QUALITY ASSURANCE -- NON-CONFORMANCE REPORT

Report No: NCR-000810

Reference Description: Heat Straightening without Engineer's Prior Approval

Job Name: SAS Superstructure
Document No: 05.03.06-000767

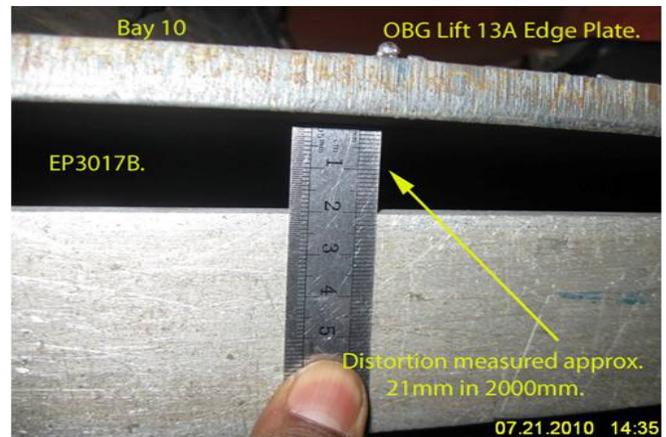
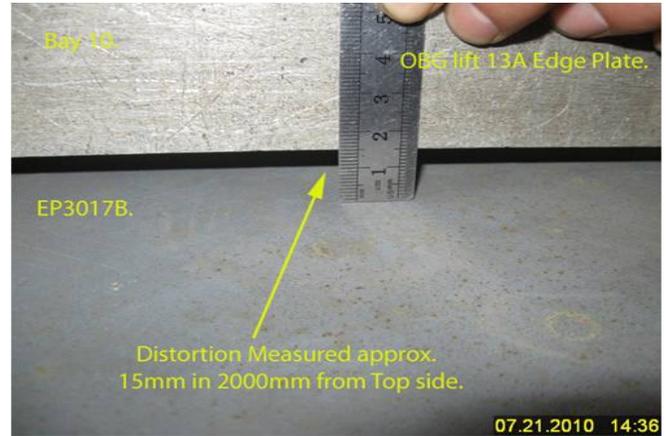
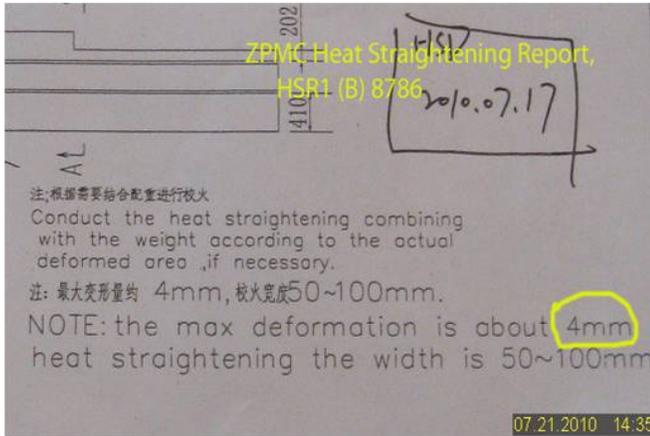
During the Caltrans Quality Assurance in-process observations of the fabrication of Edge Plate EP3017B, and EP3024A, QA discovered the following issue:

- ZPMC personnel heat straightening excessive distortion on non Seismic Performance Critical Material (NON SPCM) material distorted by welding without the Engineers approval.
- The effected Edge Plates are identified as EP3017B (PL3209A) and EP3024A (PL3353A).
- The deviation from flat as measured by this QA inspector is 35mm per 2000mm in Edge Plate (EP3024A).
- The deviation from flat as measured by this QA inspector is 21mm per 2000mm in Edge Plate (EP3017B).
- The Material thickness for both panels is 12 mm.
- This Edge Plate is located in Sub assembly Bay#10.

AWS D1.5/2002 Section 3.7.3: "Members distorted by welding shall be heat straightened by mechanical means or by carefully supervised application of a limited amount of localized heat as approved by the engineer".

Caltrans Special Provisions Section 8-3: "For material up to 16 mm, the Contractor shall not heat straighten members more than 6 in 1000 without prior approval of the Engineer".

Reference Resolution: ZPMC is providing the approved HSRs that accurately show the work that was being performed at the time of heat straightening.

ZPMC is providing the approved HSRs that accurately show the work that was being performed at the time of heat straightening. ZPMC QA talked with the production team leader and determined that he believed the HSR was approved at the commencement of work. ZPMC QA instructed him to call them next time to ensure that was the case on not assume that the work had been approved. Based on these documents, ZPMC requests closure of this NCR.

The proposed resolution is acceptable. This NCR is considered closed.

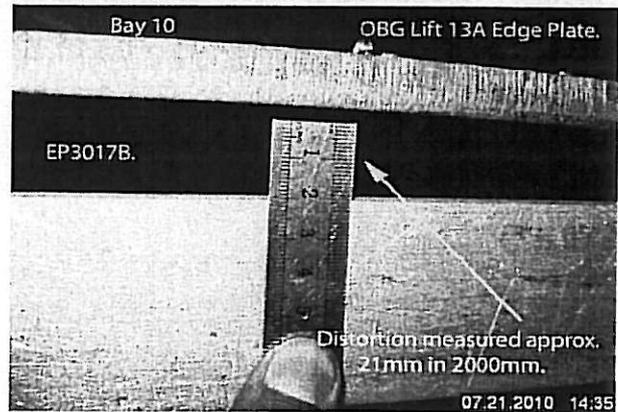
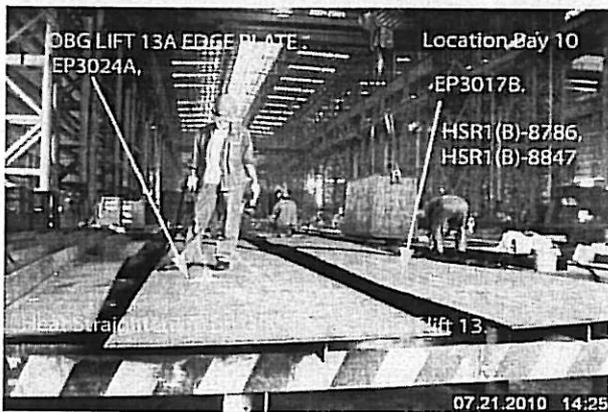
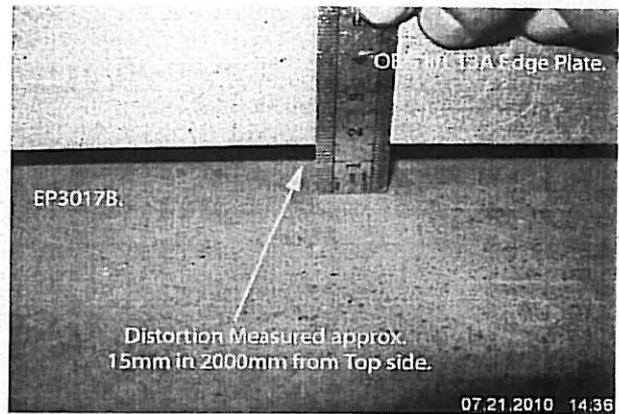
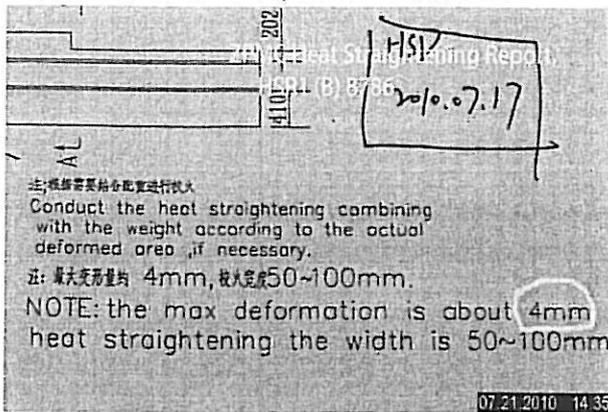
During the Caltrans Quality Assurance in-process observations of the fabrication of Edge Plate EP3017B, and EP3024A, QA discovered the following issue:

- ZPMC personnel heat straightening excessive distortion on non Seismic Performance Critical Material (NON SPCM) material distorted by welding without the Engineers approval.
- The effected Edge Plates are identified as EP3017B (PL3209A) and EP3024A (PL3353A).
- The deviation from flat as measured by this QA inspector is 35mm per 2000mm in Edge Plate (EP3024A).
- The deviation from flat as measured by this QA inspector is 21mm per 2000mm in Edge Plate (EP3017B).
- The Material thickness for both panels is 12 mm.
- This Edge Plate is located in Sub assembly Bay#10.

AWS D1.5/2002 Section 3.7.3: "Members distorted by welding shall be heat straightened by mechanical means or by carefully supervised application of a limited amount of localized heat as approved by the engineer".

Caltrans Special Provisions Section 8-3: "For material up to 16 mm, the Contractor shall not heat straighten members more than 6 in 1000 without prior approval of the Engineer".

Provide an HSR1 detailing the actual methods used in the field and perform NDT required to verify weld quality.

Contractor has made the appropriate changes to the HSR used on site detailing the work which was actually performed and has submitted subsequent NDT reports verifying the affected welds meet Contract weld quality requirements.

报告号 Report #	HSR(B)-387
版本号 Revision #	0
日期 Date	2010.07.21

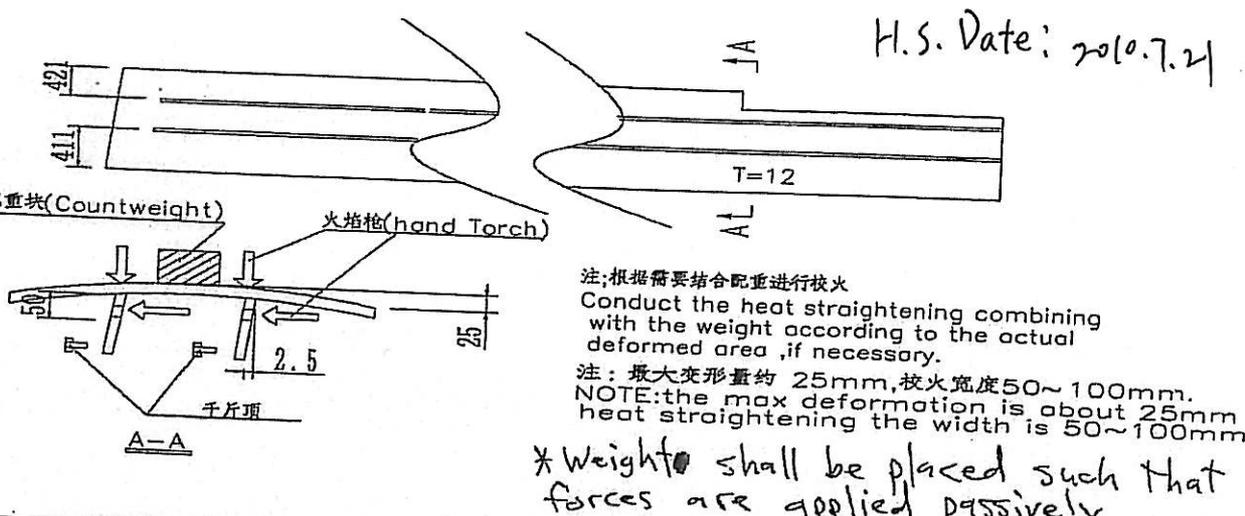
Cause 原因: Welding distortion 焊接变形

Type of Defect 缺陷类型: Welding distortion 焊接变形

缺陷去除方法(Defect Removal Method): Using hand torch and Countweight., 使用火焰枪以及配重块进行校火,
 后续NDE(Post-Removal NDE): After finishing heat straightening, the weld of the heat area shall perform 100% VT, MT and UT according to the approved shop drawing 校火后, 根据图纸要求对热影响区域进行100% VT, MT and UT 检测.

纠正措施(Corrective Action(s)): Increase the flange anti-deformation allowance during the course of fit-up, and Control the welding parameters according to associated WPS. 在装配的过程中增加反变形余量。根据相关WPS控制焊接参数。
 实施次数(Number of application): 1~3
 最高温度(Maximum temperature): 650°C

报告号 Report # HSR(B)-388
版本号 Revision # 0
日期 Date 2010.07.21

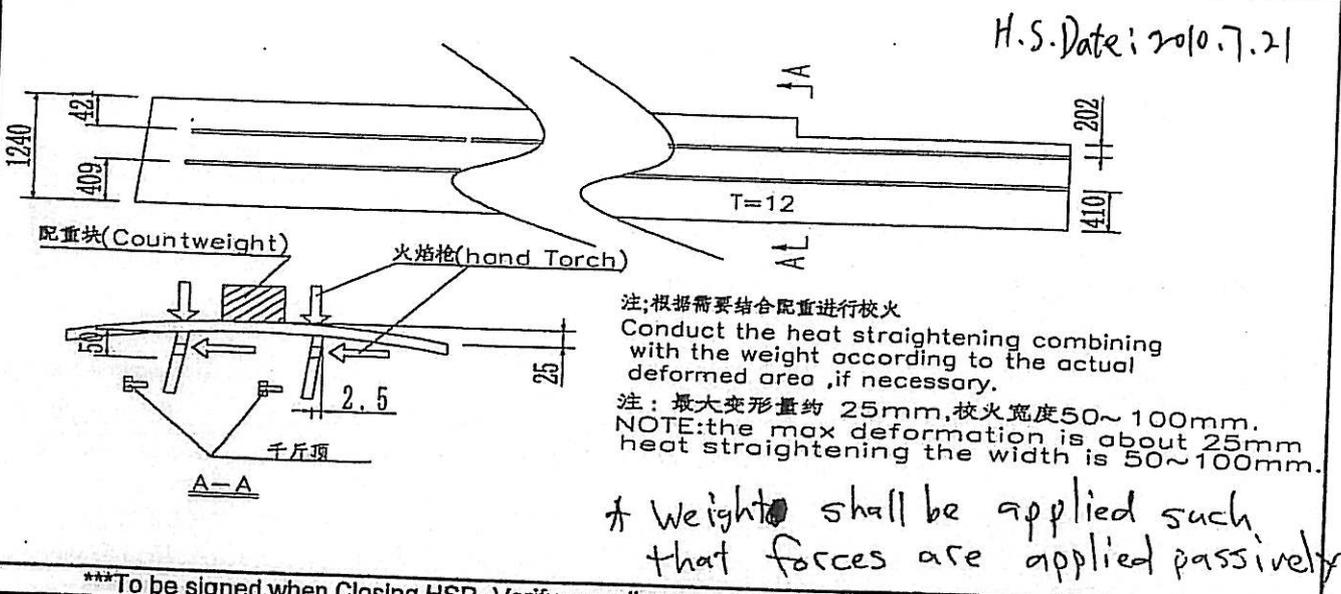
Cause 原因: Welding distortion 焊接变形
Type of Defect 缺陷类型: Welding distortion 焊接变形
Inspection Method 检查方法: Visual 目检

缺陷去除方法(Defect Removal Method): Using hand torch and Countweight. 使用火焰枪以及配重块进行校火。
后续NDE(Post-Removal NDE): After finishing heat straightening, the weld of the heat area shall perform 100% VT, MT and UT according to the approved shop drawing 校火后, 根据图纸要求对热影响区域进行100% VT, MT and UT 检测。
纠正措施(Corrective Action(s)): Increase the flange anti-deformation allowance during the course of fit-up and Control the welding parameters according to associated WPS. 在装配的过程中增加反变形余量。根据相关WPS控制焊接参数。
实施次数(Number of application): 1~3
最高温度(Maximum temperature): <650°C
